# **PRODUCT ADVISORY**

**Corrections to Standard  
Microcircuit Drawing  
5962-95729 for Intersil  
Product HCS154\***

**Refer to:  
PA10091**

**Date: September 21, 2010**

## Incorrect Logic Diagram – PA10091

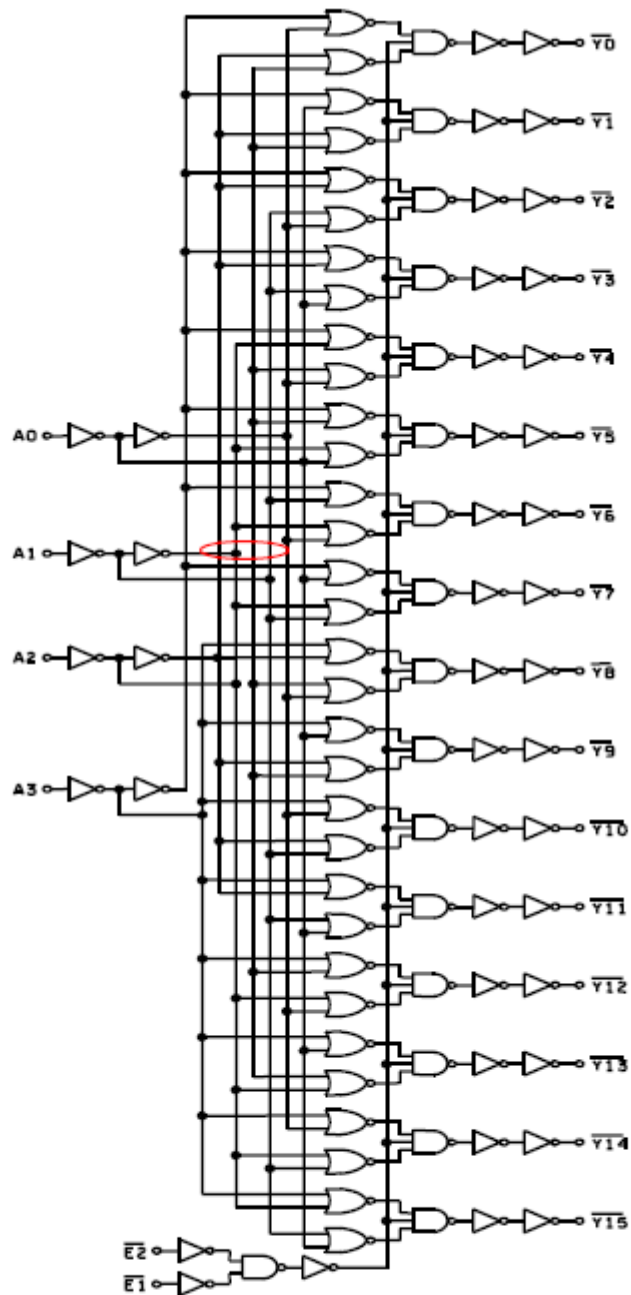
This advisory is to inform you that Intersil has made corrections to DSCC (Defense Supply Center Columbus) SMD (Standard Microcircuit Drawing) 5962-95729 for the HCS154\* products. The updates correct errors in the Truth Table (Inputs A0 – A3 were reversed) and Logic Diagram (Input A1 connection). There have been no changes of any type to the screening or product itself. The updates to the DSCC SMD are complete. The released SMD is available on the DSCC website at <http://www.dsccl.mil/downloads/milspec/smd/95729.pdf>.
